HINCKLEY NATIONAL RAIL FREIGHT INTERCHANGE

Appendix 2 - Sapcote Technical Note

Tritax Symmetry (Hinckley) Ltd
Hinckley National Rail Freight
Interchange
Sapcote Highway Mitigation Technical
Note

Figure 3.2 - Key Pinch Points in the Centre of Sapcote

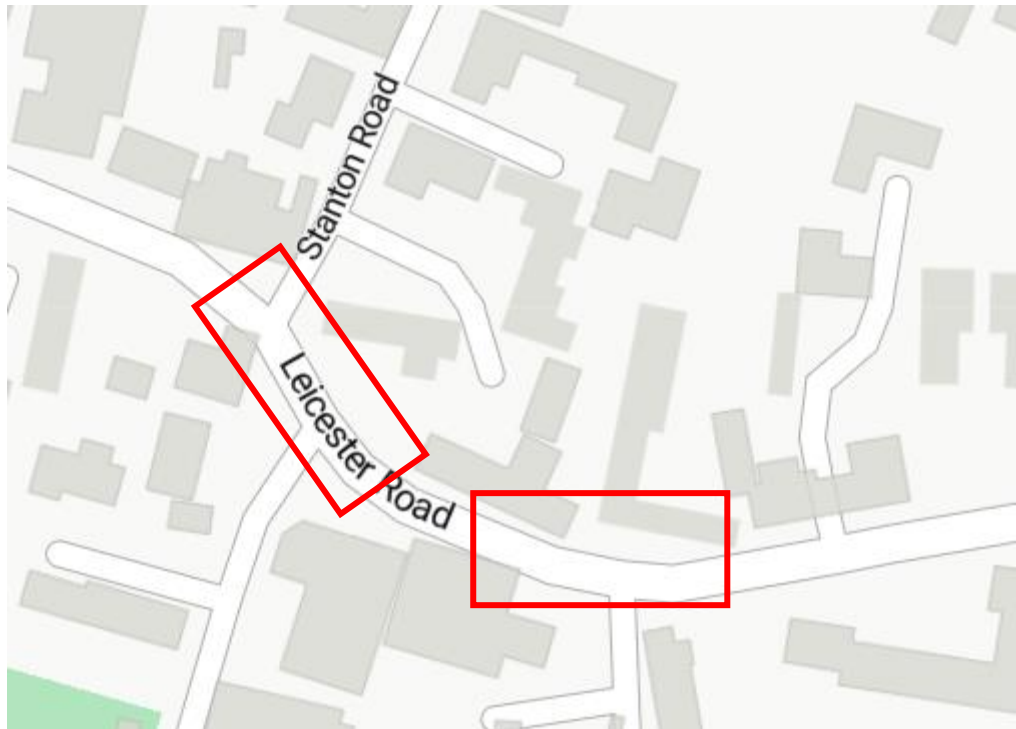
3.5 There are two key pinch point areas on the B4669 where the existing carriageway and surrounding infrastructure is narrow and there is not sufficient space to permit two large HGVs to pass each other within the extents of the carriageway. These are highlighted on Figure 3.2 and are as follows:

- Outside the Co-op where the existing 'bendiness' of the road and the presence of central refuge islands means that large HGVs can presently be forced to mount the narrow footways and central refuge islands in order to pass. The central refuge means that this is the case even if there is no vehicle travelling in the opposite direction; and
- To the east of the Co-op around New Walk the carriageway is narrow and two HGVs travelling in opposite directions are presently unable to pass each other.

Figure 5.1 - Existing Vehicle Tracking Outside Co-op with conflict area clouded in blue

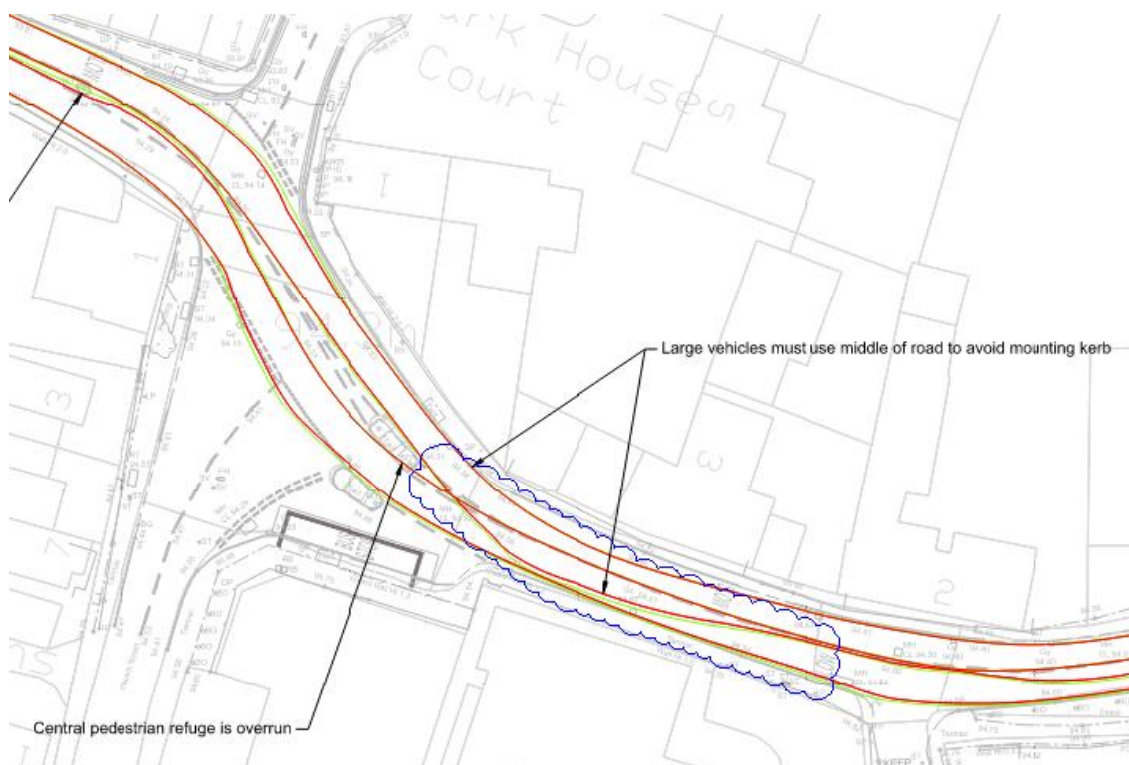
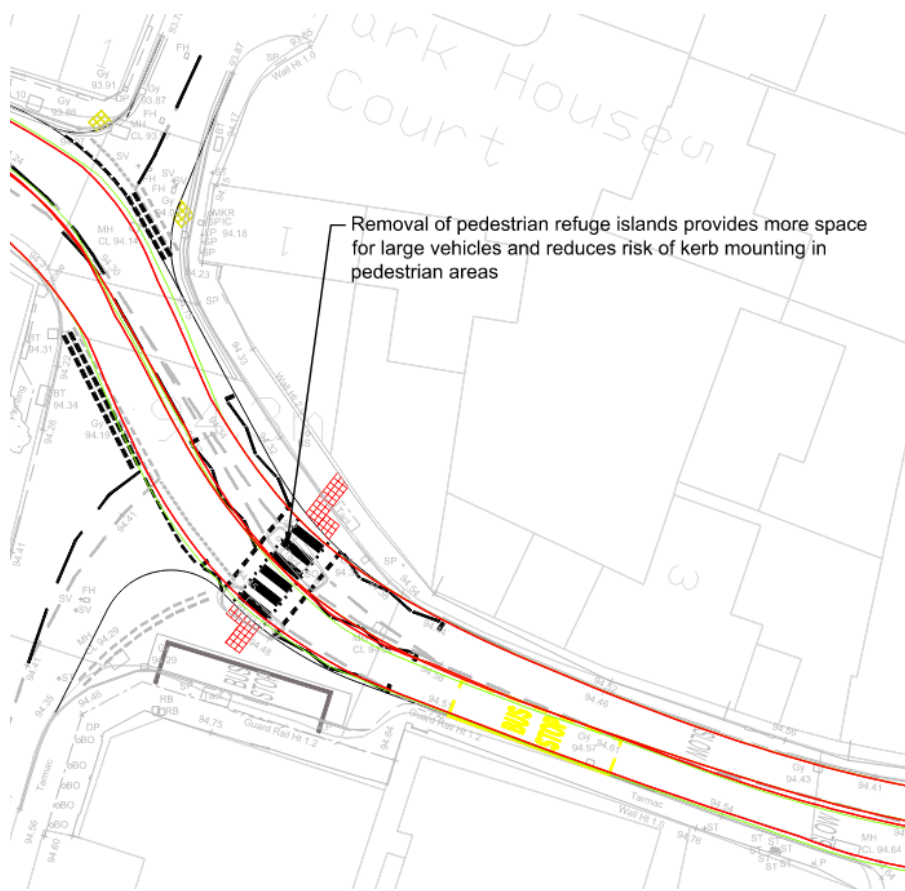
- 5.2 The ExA were not satisfied with the Applicant's response to the Stage 1 RSA for the area outside the Co-op store. The ExA's Report includes two figures from the vehicle tracking drawings submitted to the Examination. Figure 9 shows the existing swept paths of large vehicles through the area outside of the Co-op and Figure 10 shows the proposed swept paths of the same vehicles once the works have been completed. Paragraph 3.3.522 states that *'there has been no realignment to allow HGVs to pass'* however as explained in Chapter 4 of this technical note, the original proposals included the removal of the central crossing island and significant realignment of the northern kerb line, meaning that HGVs would be able to pass each other through the section where they cannot at present. Extracts from the relevant drawings are included below as Figures 5.1 and 5.2 with the areas in question highlighted.

- 5.3 These figures show the swept paths of two 'max legal' HGVs (i.e. the largest permitted on UK roads) and therefore represent the very worst case. The term 'HGV' where used in the modelling refers to a number of different vehicles as shown in Figure 2.1.

- 5.4 As can be seen from the Figures above, the removal of the pedestrian refuge and proposed works in the area result in significant widening of the northern kerb line and enable large vehicles to pass through this area without coming into conflict with each other. This does not appear to have been taken into account by the ExA in their reporting, and as explained in paragraph 5.2 above the ExA's analysis seems instead to have been influenced by a significant factual misunderstanding.

Figure 6.1 - Manual for Streets Illustration of Carriageway Widths

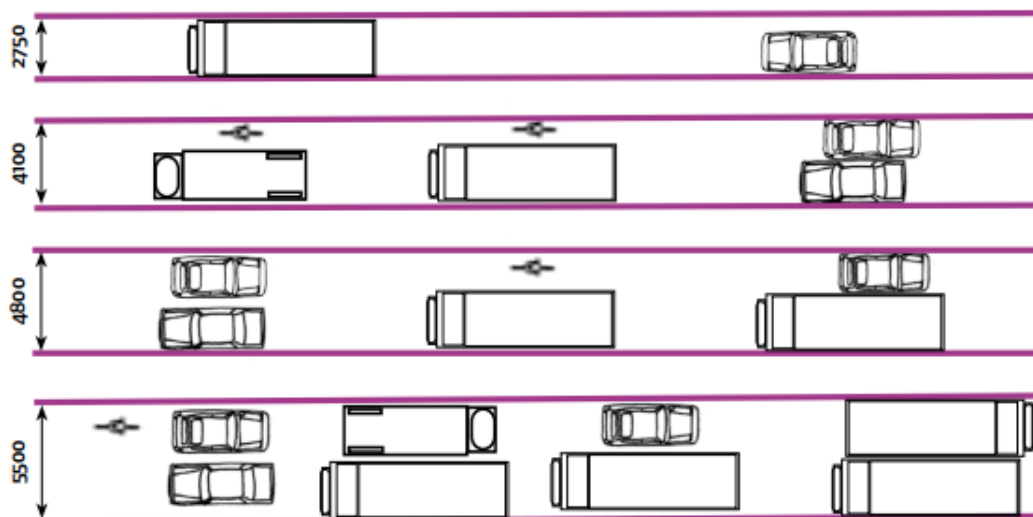
- 6.16 The final option considered reduces the width of this section of carriageway to 4.8m in order to provide a better visual cue to drivers of large vehicles that there is insufficient space for them to pass. This width accords with Figure 7.1 of Manual for Streets (shown below as Figure 6.1).

- 6.17 White lining has been shown on the Highway Plans to encourage drivers of large vehicles to use the middle of the road, although the provision of this is subject to Overseeing Organisation agreement at detailed design stage pursuant to the DCO. The realignment of the carriageway to the east and west of this section improves overall forward visibility to oncoming vehicles.
- 6.18 Cars and light vans are still able to pass each other through this section as illustrated by Figure 6.1 and the vehicle tracking drawings at Appendix B, but the reduction in overall carriageway width means that two coincident HGVs are unlikely to try and pass each other due to the carriageway not appearing to be of a suitable width. These vehicles are therefore more likely to wait for oncoming vehicles to pass.

Figure 6.6 - A606 in Nether Broughton, Leicestershire

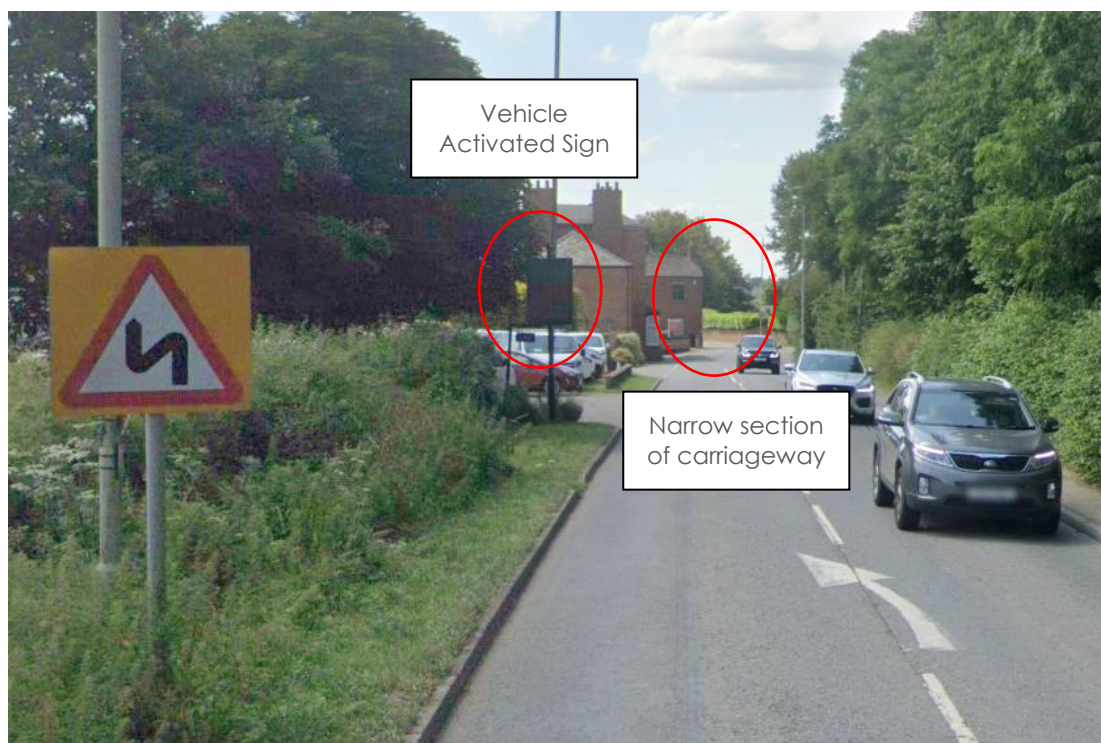
- 6.70 Vehicles travelling westbound approach a series of tight bends with buildings protruding into the carriageway. Historically, these were demarcated by road markings however in recent years kerbing has been installed to divert vehicles away from the buildings and dedicate space to pedestrians.

- 6.71 Vehicle activated signage with an illuminated 'series of bends ahead' warning sign to Diagram 513 and the text SLOW DOWN is used in support of fixed signage. In the opposite direction, diagram 513 with an 'oncoming vehicles in the middle of the road' plate is used. Figure 6.6 shows the narrow section, VAS and fixed signage.

- 6.72 In the last 5 reported years there have been no recorded PICs on this stretch of the A606.
- 6.73 It is the Applicant's view that the examples given above, along with the numerous other examples of narrow roads through villages across the UK which do not have VAS and the independent road safety auditor's view that the designer's response and updates mitigate the road safety issues raised demonstrate that the Enhanced scheme in Sapcote does not have any fundamental highway safety issues associated with it and can be delivered to operate safely for both motorists and non-motorised traffic.
